SITE INSTRUCTION NO. ME-08
MECHANICAL AND ELECTRICAL

Project Name: Carleton Place Arena
75 Neelin Street
Carleton Place, Ontario

M8.1 CIR #27 – RTU Orientation:

REQUEST FOR INFORMATION

M102

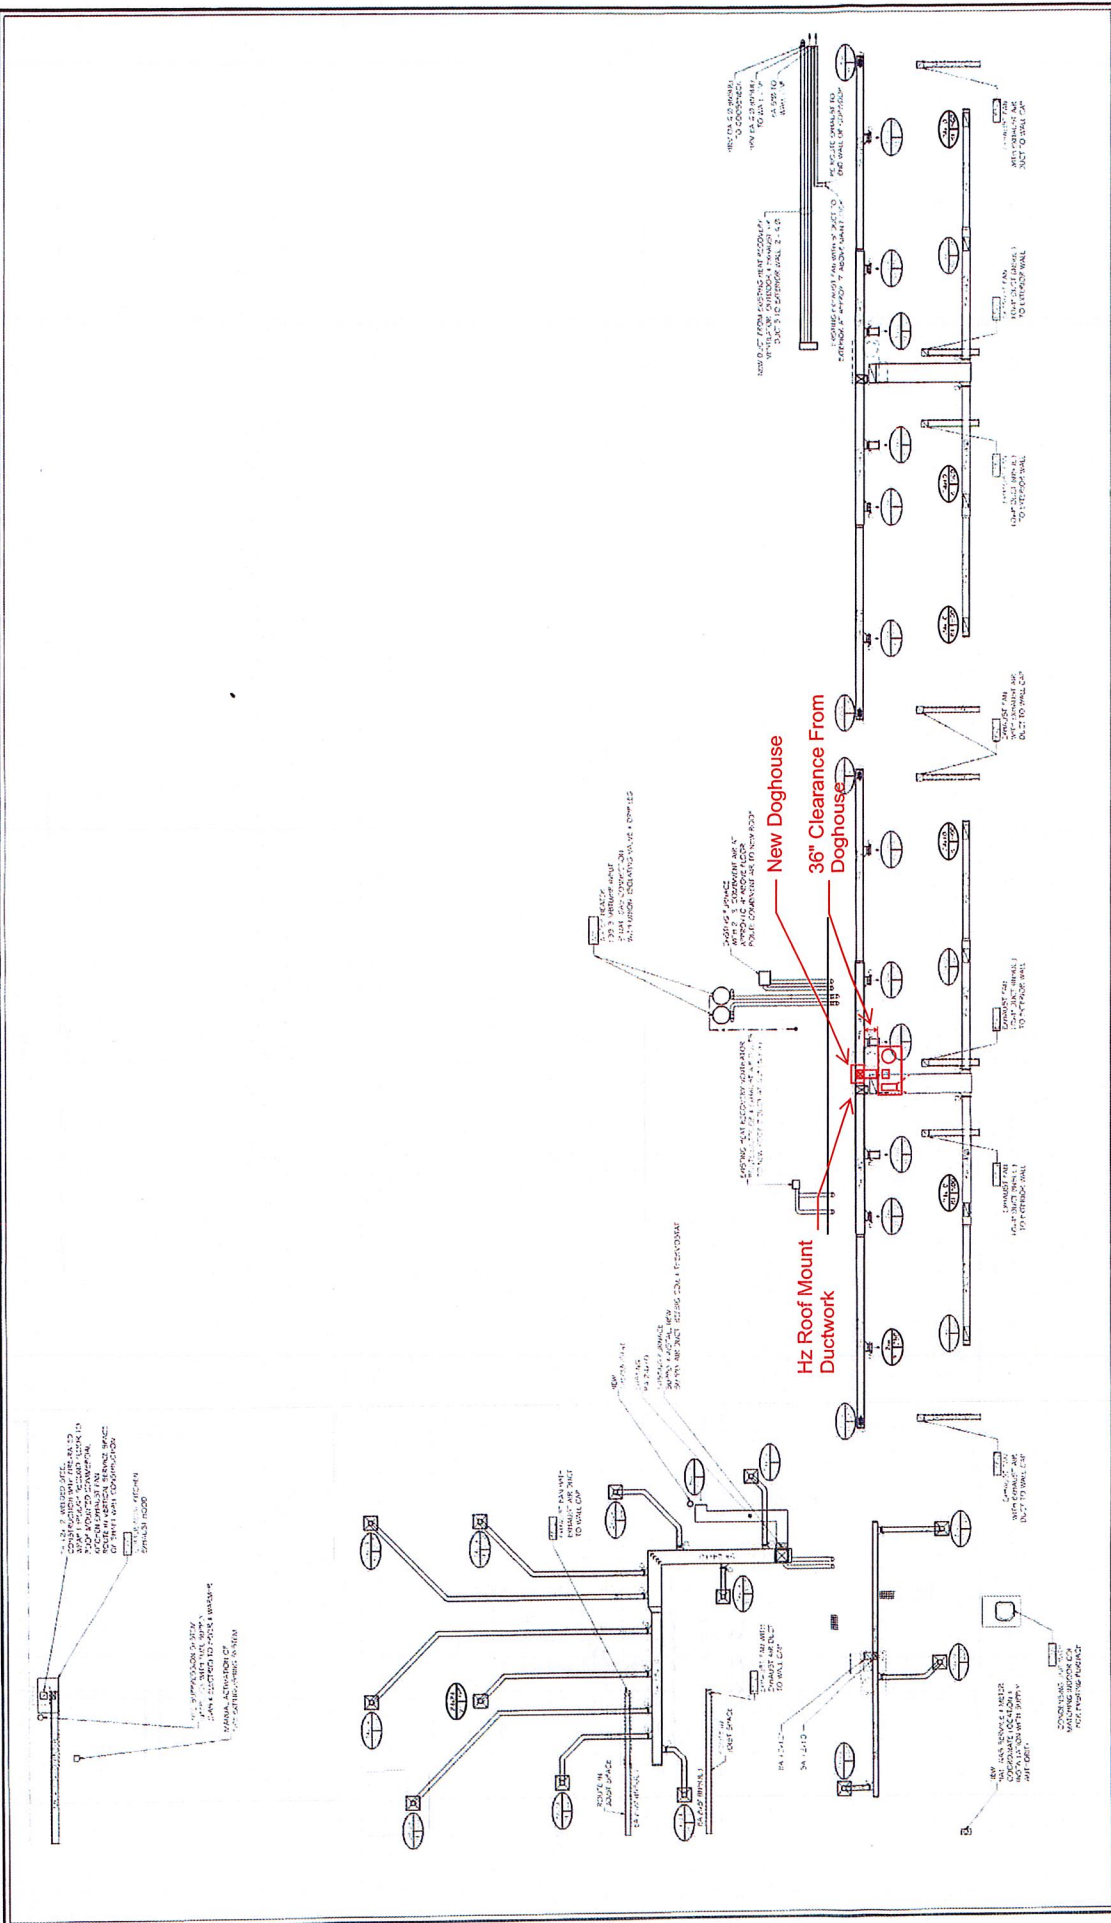
The alternate Lennox RTU needs 36" of clearance from either end. This will push the supply air discharge into the change rooms. The mechanical design was based on a Carrier RTU and this unit would have the same problem. See attached documents.

Our proposed solution it to move the unit to respect the proper clearance and side discharge the supply air to bring the drop into the corridor to keep the existing ductwork layout.

Proposed orientation of the unit, with short run of supply air duct on the back of the unit, is acceptable.

Mechanical Contractor's claim that "The mechanical design was based on a Carrier RTU and this unit would have the same problem" is incorrect, as the CARRIER unit would not have the clearance issues due to the different orientation of the supply and return air openings in the Roof Curb. Also, offsets could have been made in the roof curb to span the 8" bond beam.

Exterior duct shall be insulated as follows:

- .1 All exterior ductwork shall be insulated with a 50mm (2in) layer of fiberglass insulation with protective cover.
- .2 Insulation shall be semi-rigid fiberglass insulation, with factory-applied, vapour retarder jacket (Kwikflex or approved equal).
- .3 Protective cover shall be pre-fabricated, self-adhering, sheet-type protective membrane, with uv-resistant aluminum weathering surface, over high-density, cross-linked polymer film, and a rubberized asphalt adhesive which sticks directly to the insulation facer (Flexclad or approved equal).
